HISTORIC AND DESIGN REVIEW COMMISSION

October 18, 2017

HDRC CASE NO: 2017-526
ADDRESS: 228 LAVACA ST
LEGAL DESCRIPTION: NCB 713 BLK 10 LOT E 3.7 OF N 95.1 OF 14, W 9 OF N 91.5 OF 15 & W 45.1 OF E 49.1 OF 15
ZONING: RM-4, H
CITY COUNCIL DIST.: 1
DISTRICT: Lavaca Historic District
APPLICANT: Clint Belew
OWNER: Clint Belew
TYPE OF WORK: Construction of a rear addition, fencing
REQUEST:

The applicant is requesting a Certificate of Appropriateness for approval to construct a rear addition to feature approximately 400 square feet.

PROPOSED FENCE @ LAVACA STREET No Scale

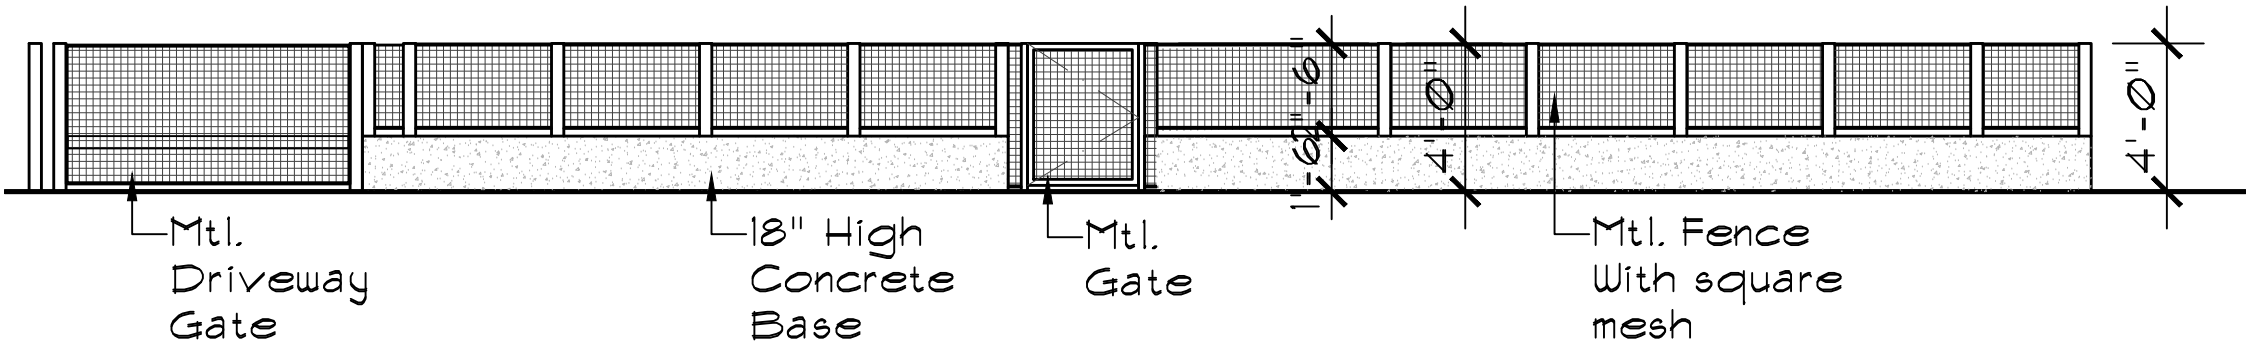
- h. FENCING – The applicant has proposed to construct a front yard fence to feature metal cattle panels and metal posts. Front yard fencing is appropriate in the Lavaca Historic District. Staff finds the proposed materials and location to be appropriate and consistent with the Guidelines.

RIGHT ELEVATION SC : 1/4" = 1'-0"

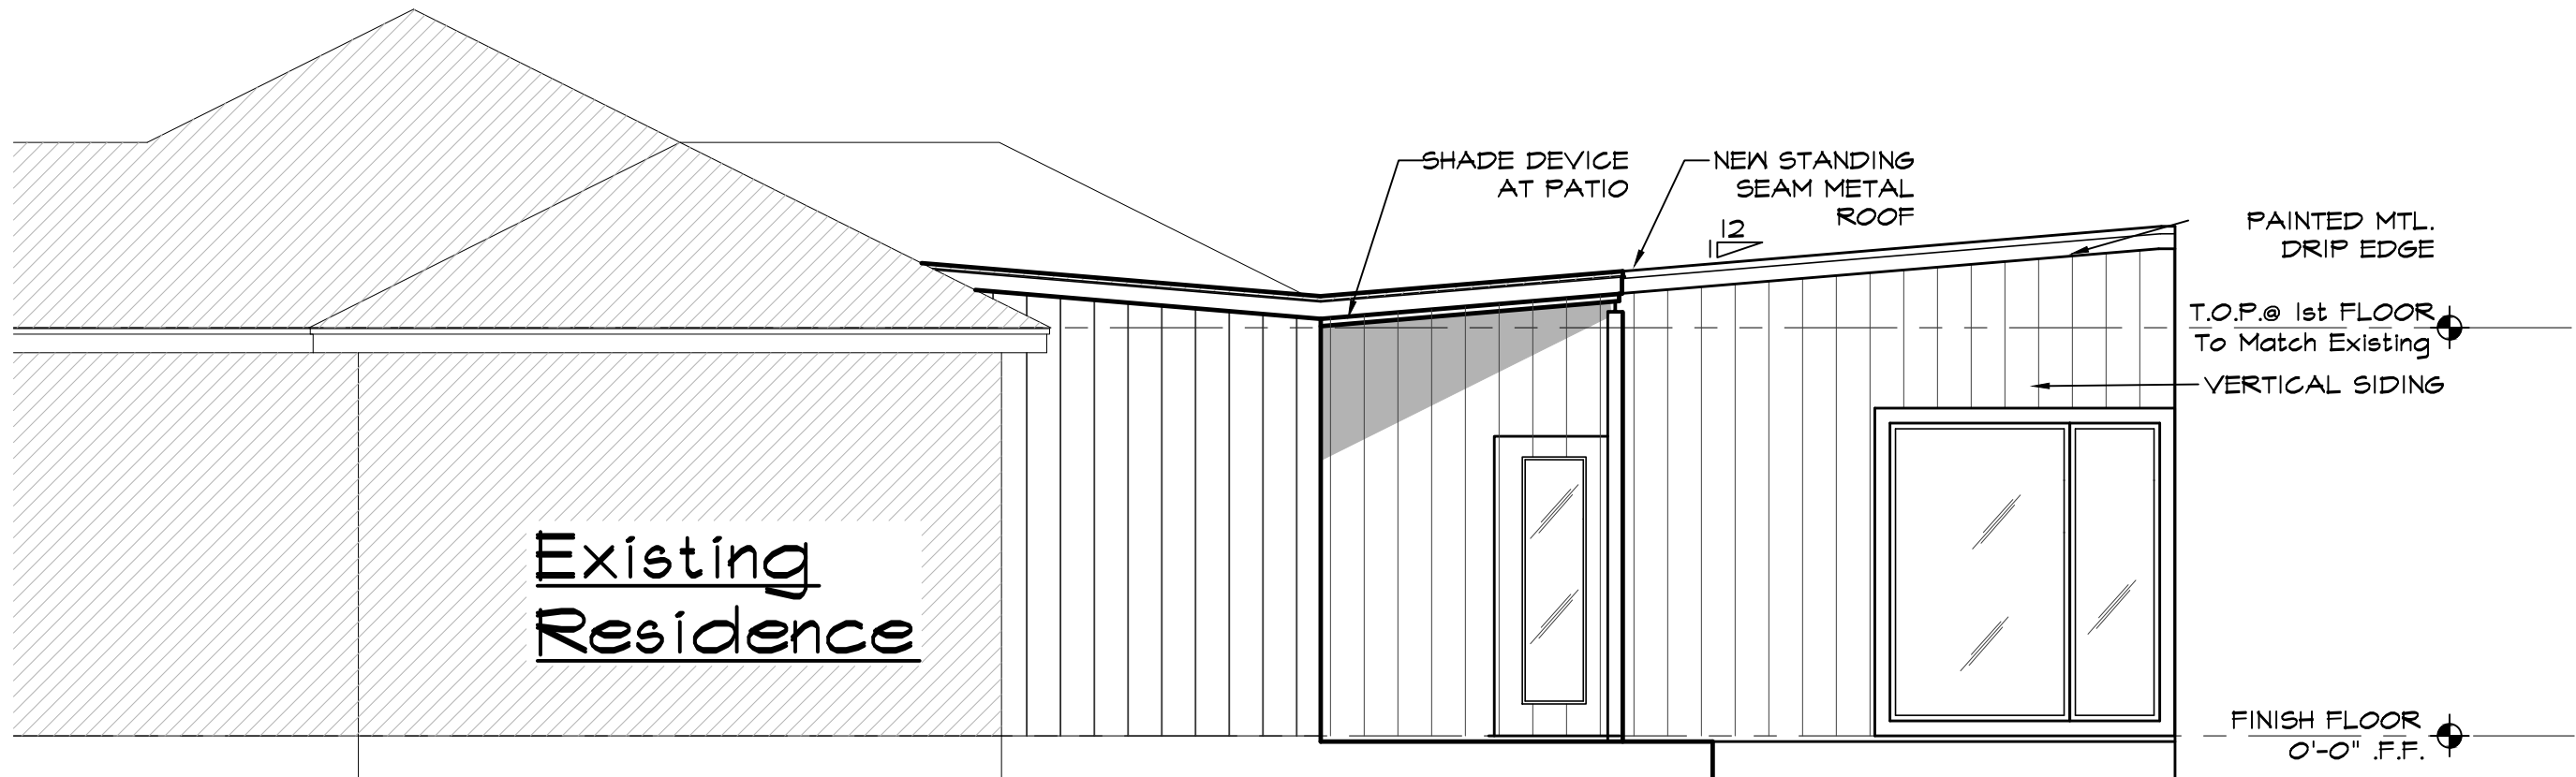
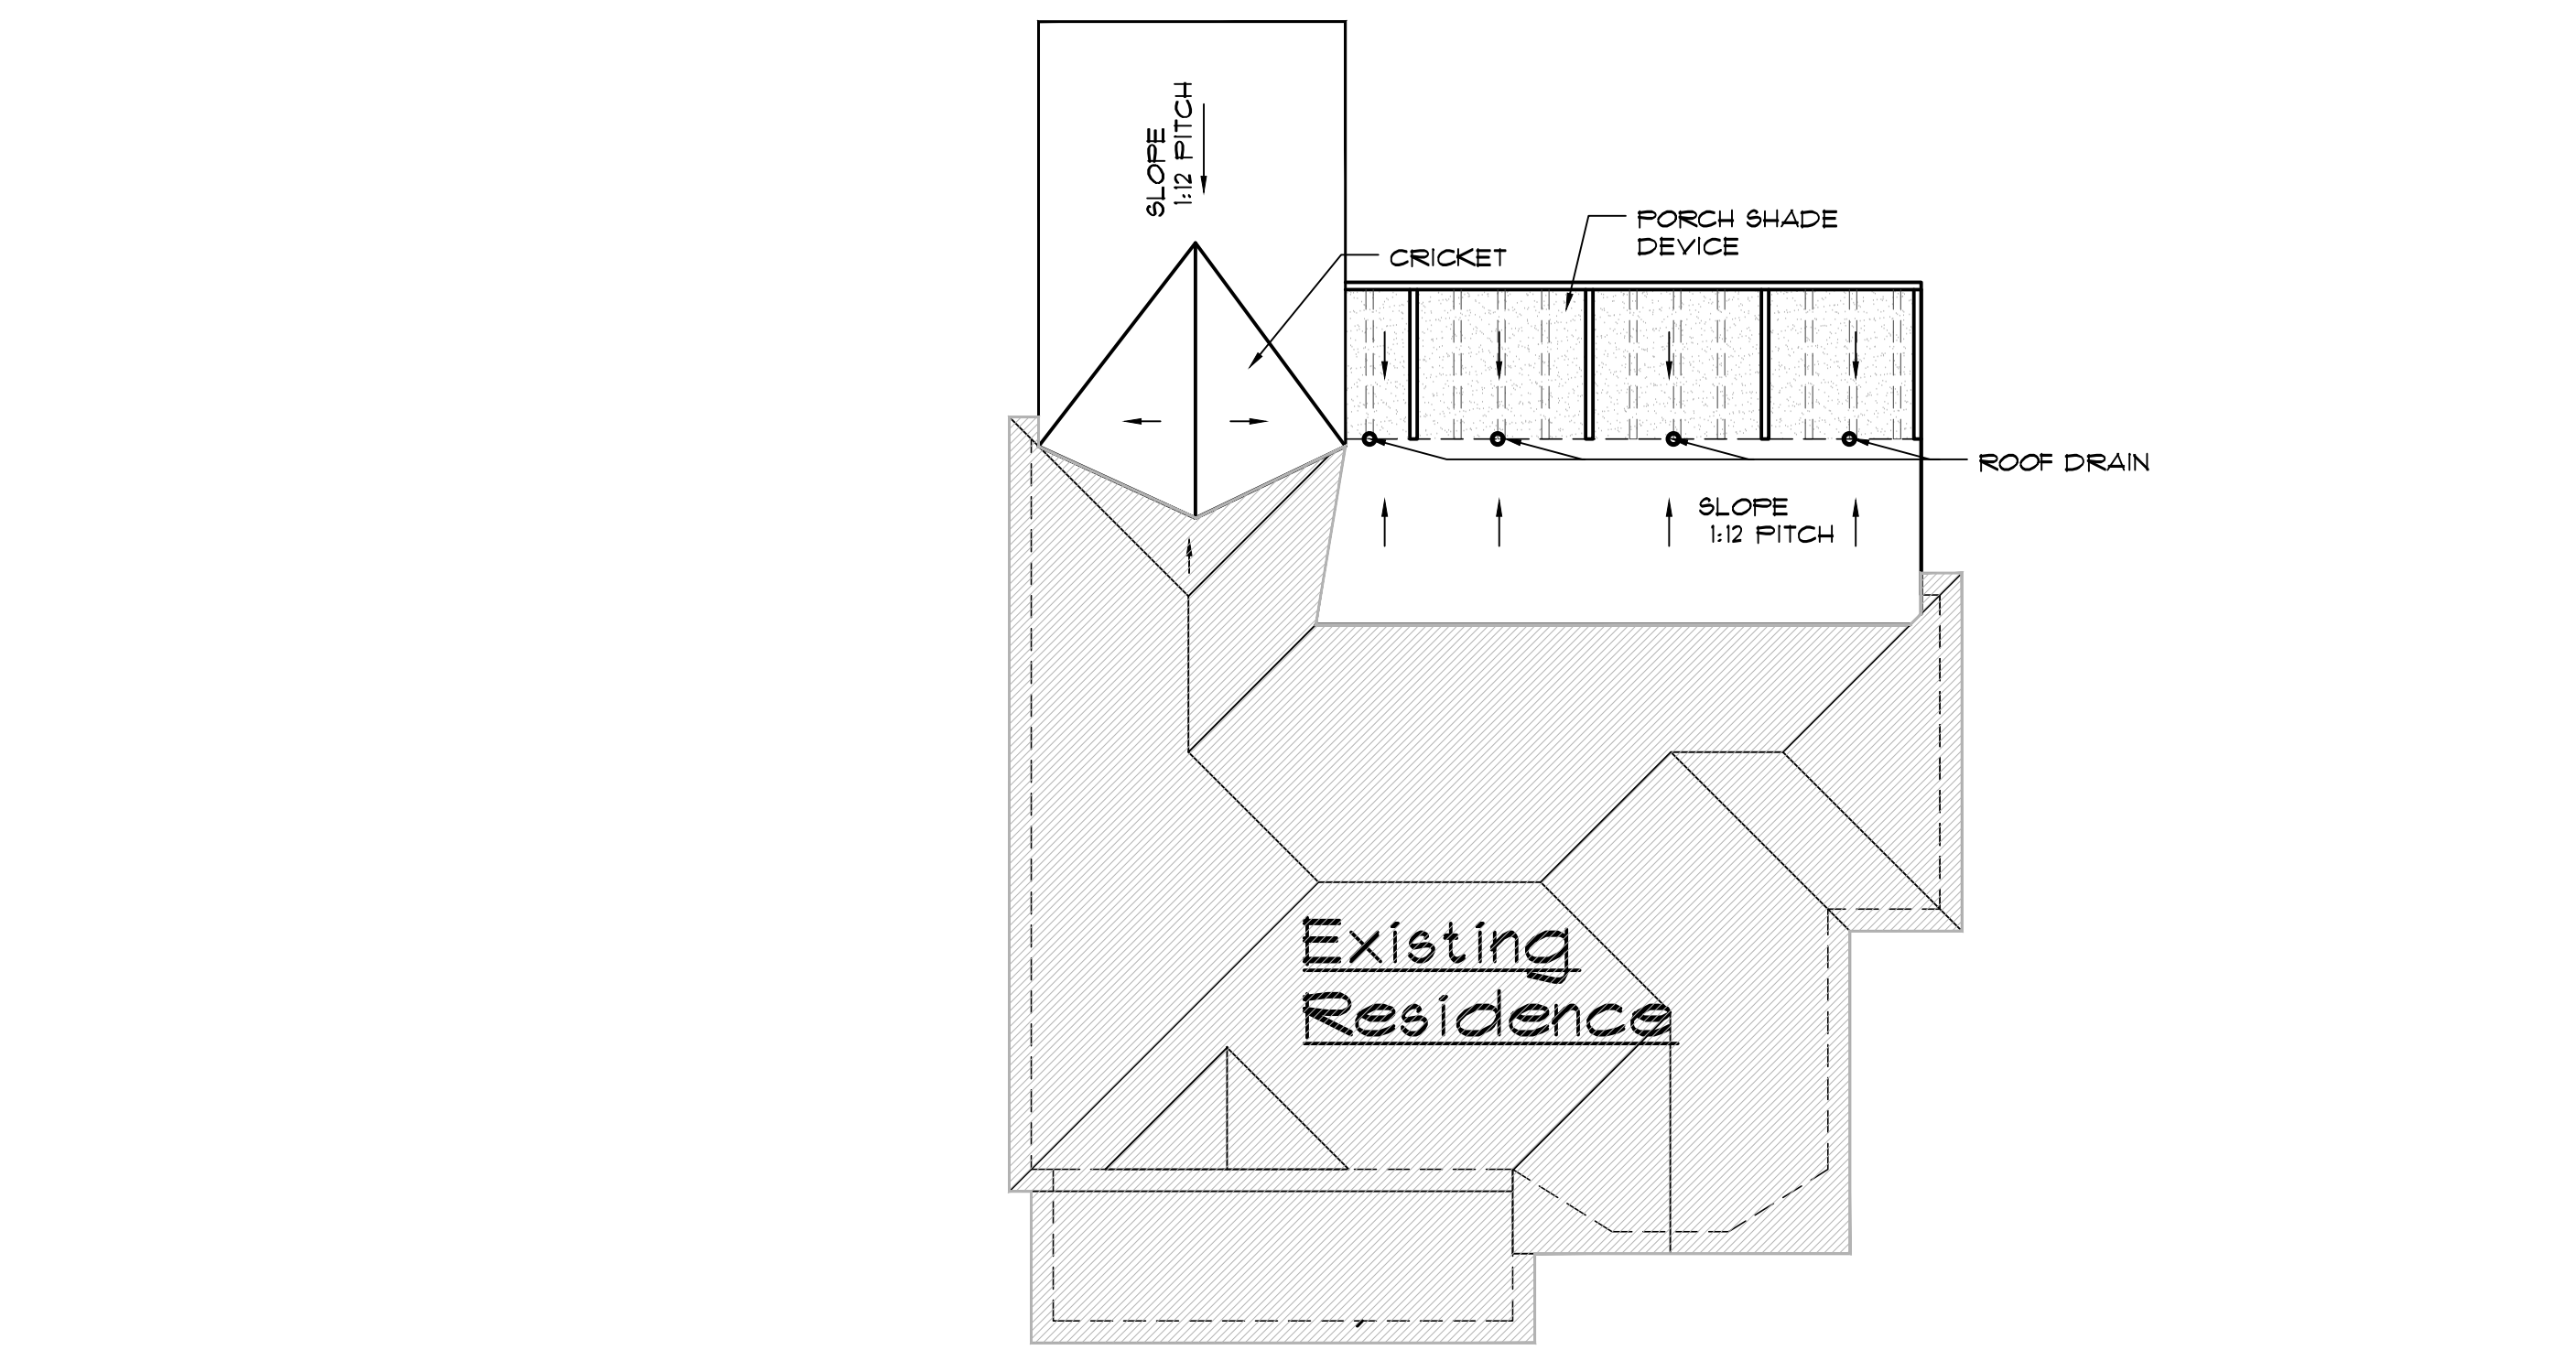
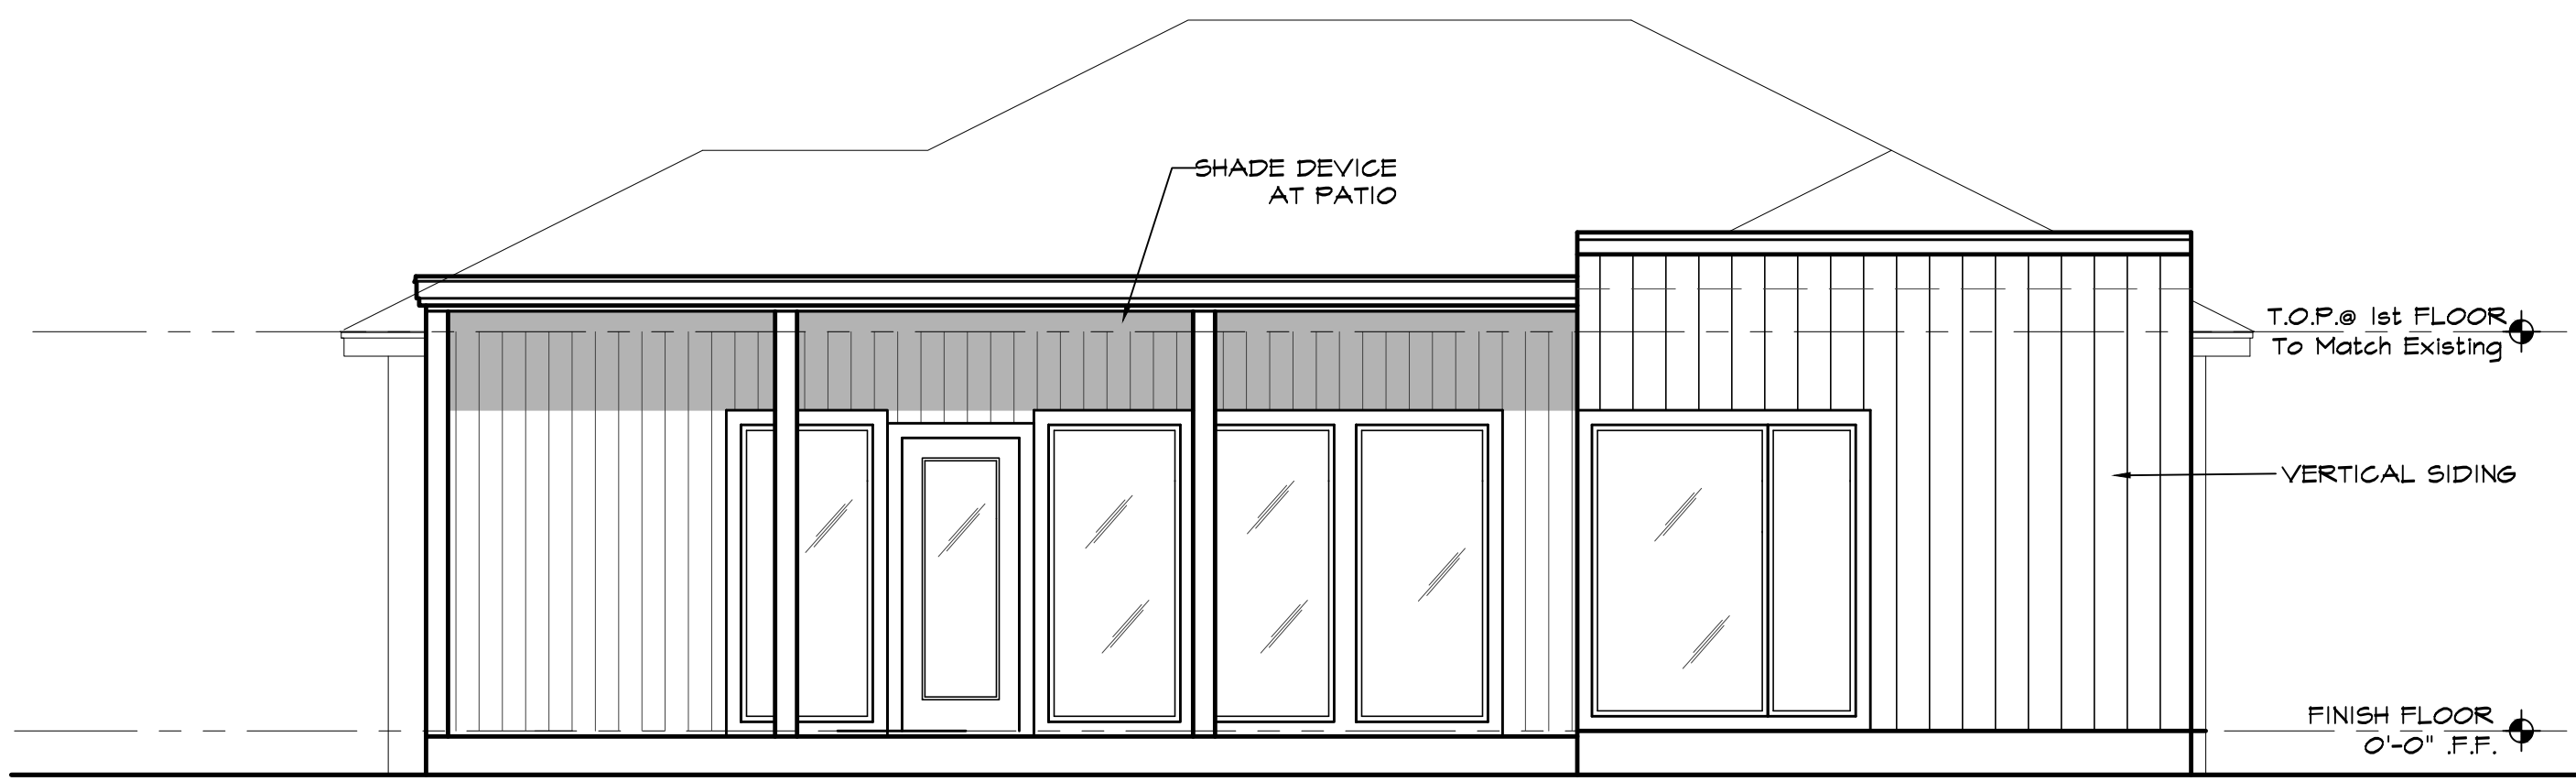
- c. **REAR ADDITION** –At the rear of the primary historic structure, the applicant has proposed to construct a rear addition to feature one story and approximately 400 square feet. The Guidelines for Additions 1.A. states that additions should be sited to minimize visual impact from the public right of way, should be designed to be in keeping with the historic context of the block, should utilize a similar roof form and should feature a transition between the old and the new. The applicant has proposed an addition with an inward sloping shed roof and insets from the wall planes of the historic structure. At the September 20, 2017, HDRC hearing, staff's concerns centered around the proposed roof form extending above that of the primary historic structure. As currently proposed, the roof form still extends above that of the primary historic structure.

- d. **SCALE, MASS AND FORM** – Regarding scale, massing and form, the applicant has proposed an addition that generally features a footprint and height that is appropriate and consistent with the Guidelines; however, staff finds that the proposed roof form should be completely subordinate to that of the primary historic structure.

- i. That the proposed addition's roof form be completely subordinate to that of the primary historic structure.
- ii. That the proposed metal siding feature a profile that is similar to historic wood siding found throughout the district (a four inch exposure).

LEFT ELEVATION SC : 1/4" = 1'-0"

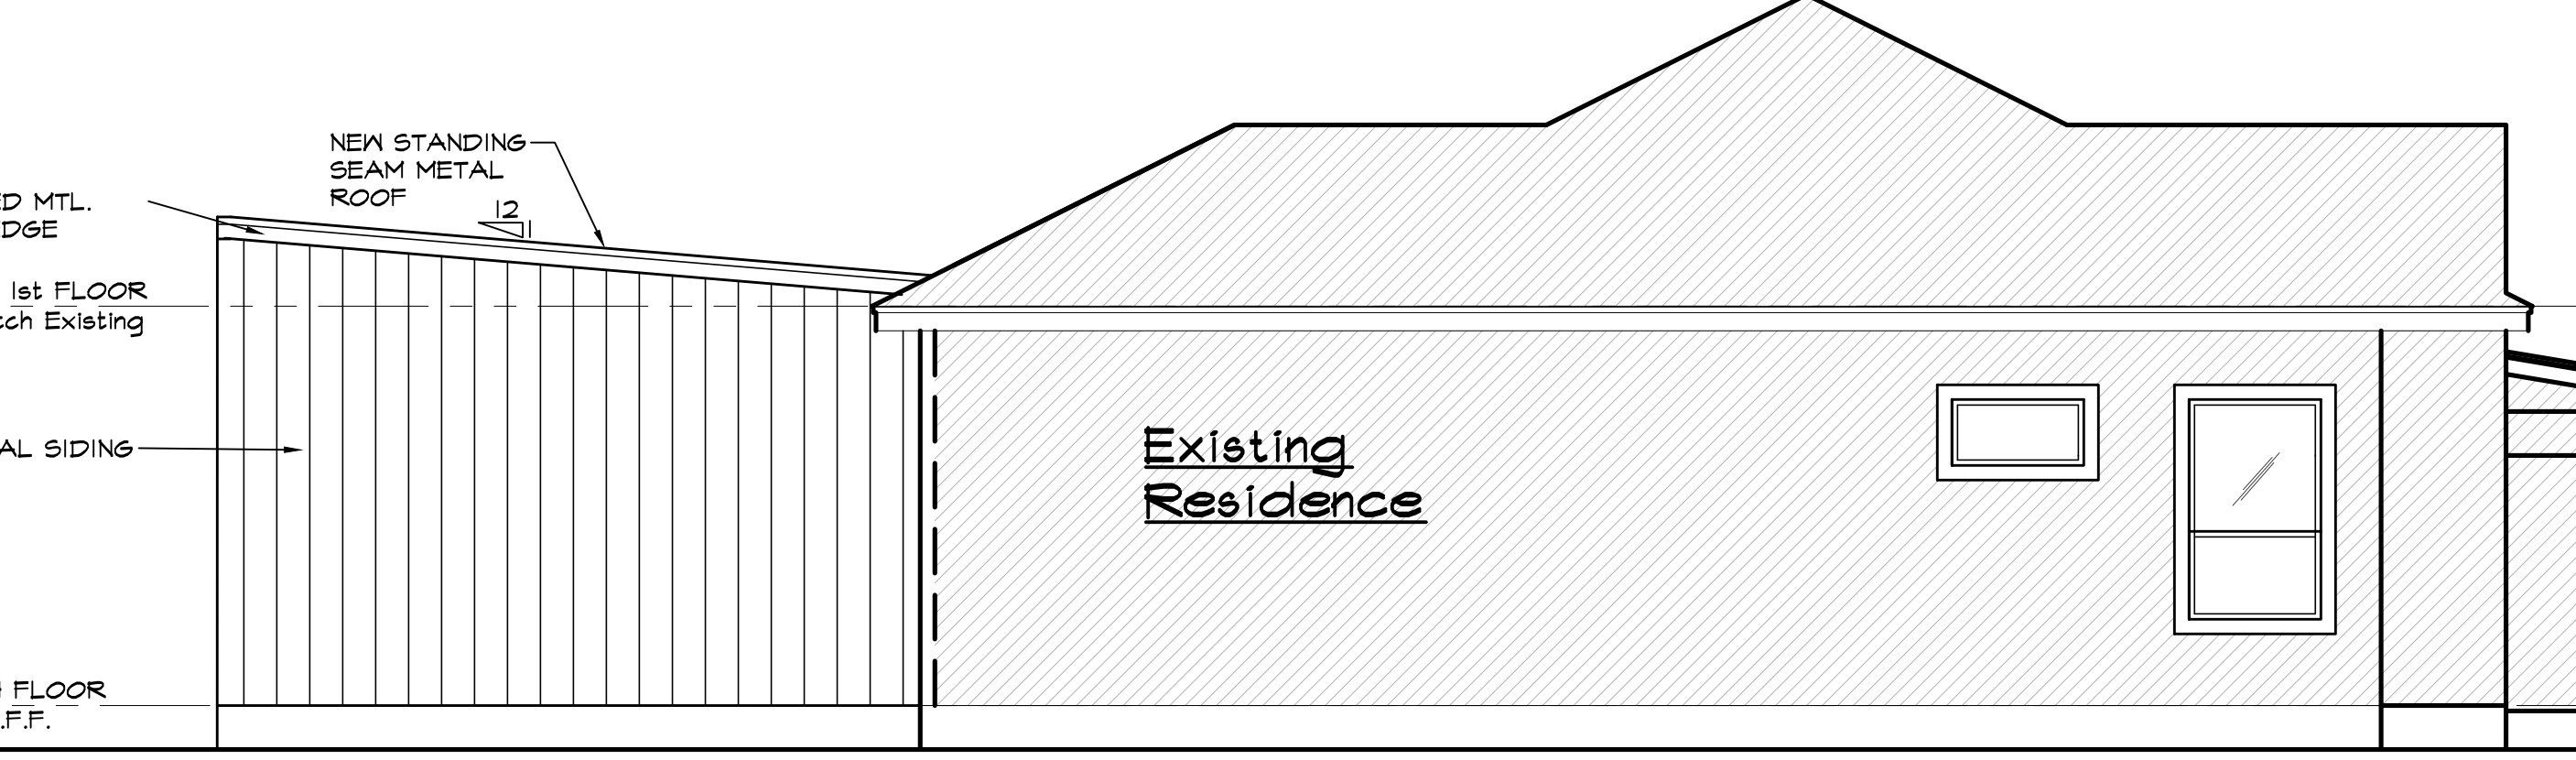
- f. ARCHITECTURAL DETAILS – As noted in finding c, staff does not find the proposed roof form to be appropriate. Additionally, the applicant has proposed for the addition to feature a wall that is void of window openings. Staff finds that additional fenestration should be added to the left elevation and that window openings that are grouped and sized similarly to those found historically in the district be used.

- iii. That the metal columns feature a profile and dimensions similar to those of the historic structure.
- iv. That additional fenestration should be added to the left elevation and that window openings that are grouped and sized similarly to those found historically in the district be used.
